### Remarks

This amendment responds to the official action mailed April 2, 2010 and is timely due to an accompanying extension under 37 C.F.R. §1.136(a).

Attorney Docket: D4700-00427  
[P 43854 WO/US]

FIG. 1

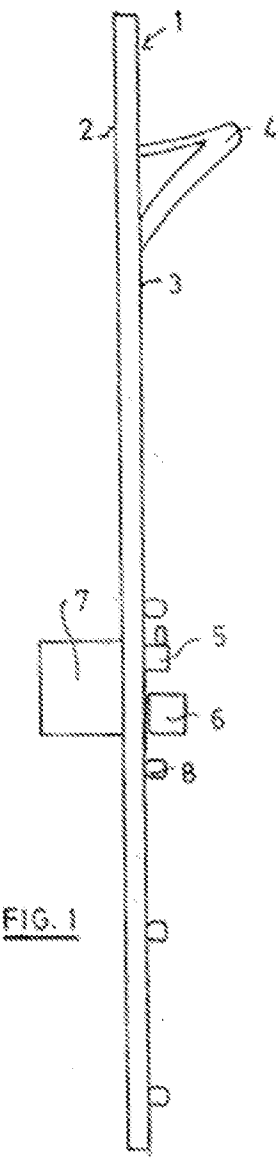
Align figure  
to sheet

FIG. 2

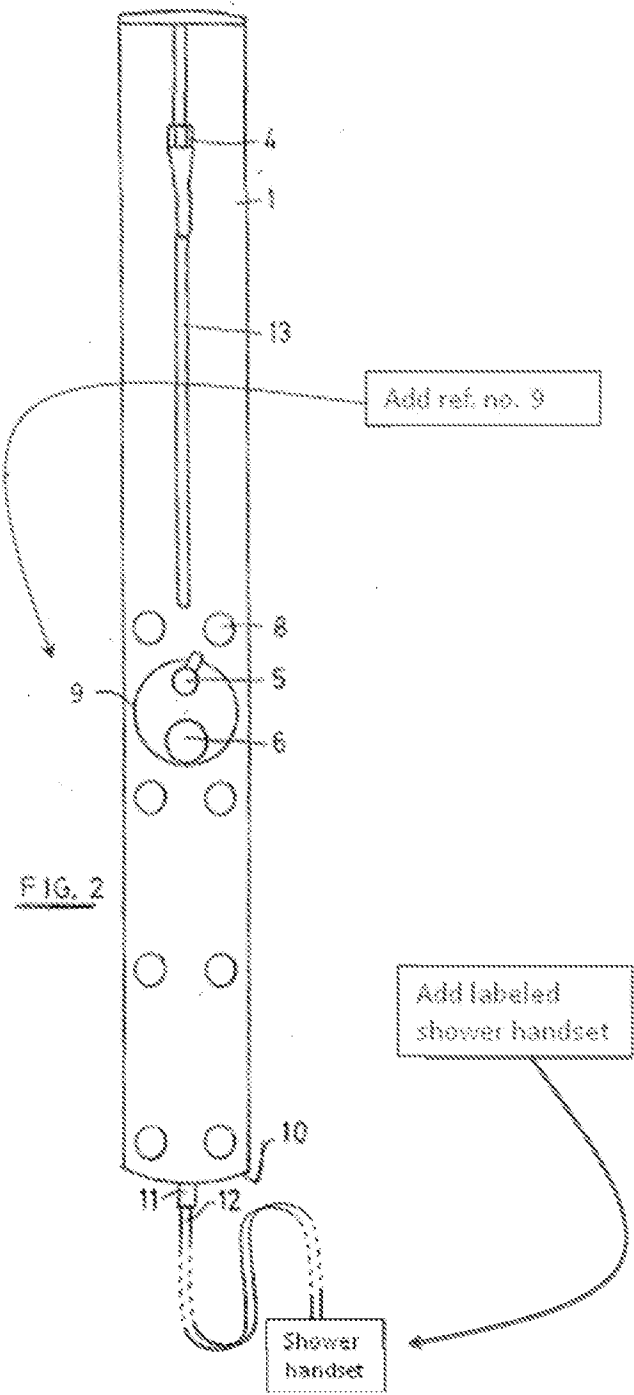
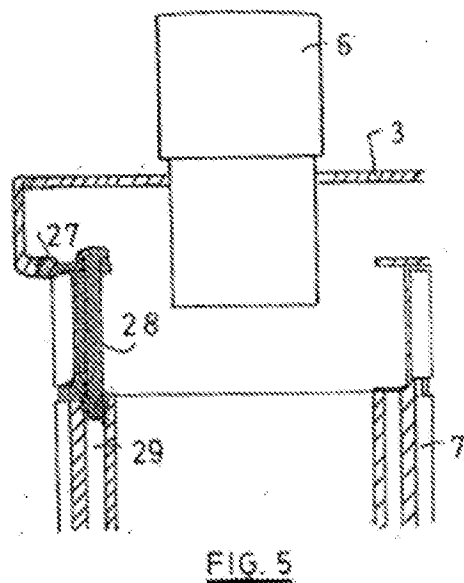
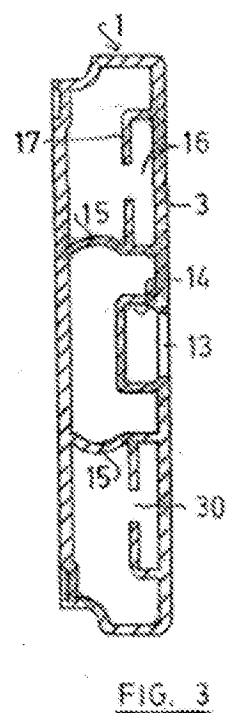
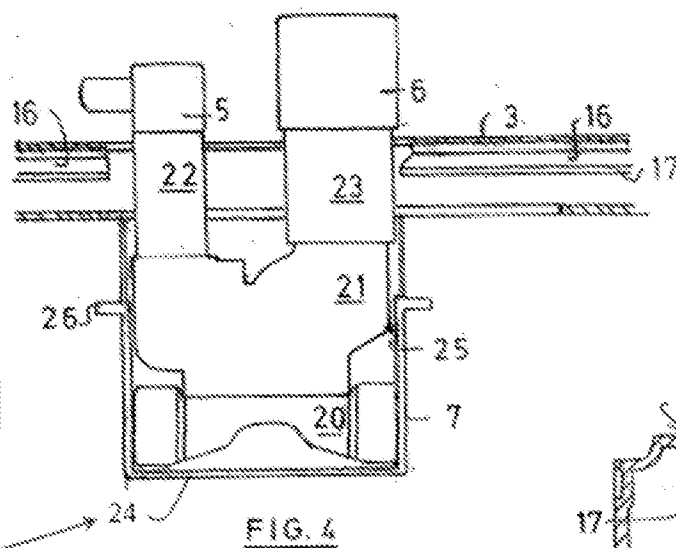
Applicant proposed to insert a schematically illustrated shower handset as a labelled box in Fig. 2, on the water deliver path defined by the hose 12 consistent with paragraph [0032] (see page 5, lines 16-20). The handset is one of plural alternative discharges, another being the shower head(s) 8, for example. Additionally, the disclosure provides for other hoses for water delivery, including within the profile, such as a hose coupled with the hose clamp fittings shown in Fig. 7 and described at paragraph [0043] (see page 8, lines 4-10).

Align figure  
to sheet

Add ref. no. 24

FIG. 6

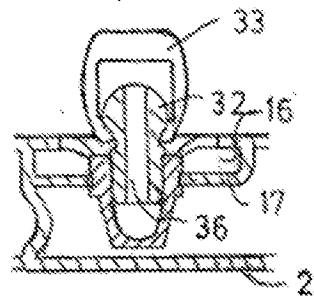
Align figure  
to sheet
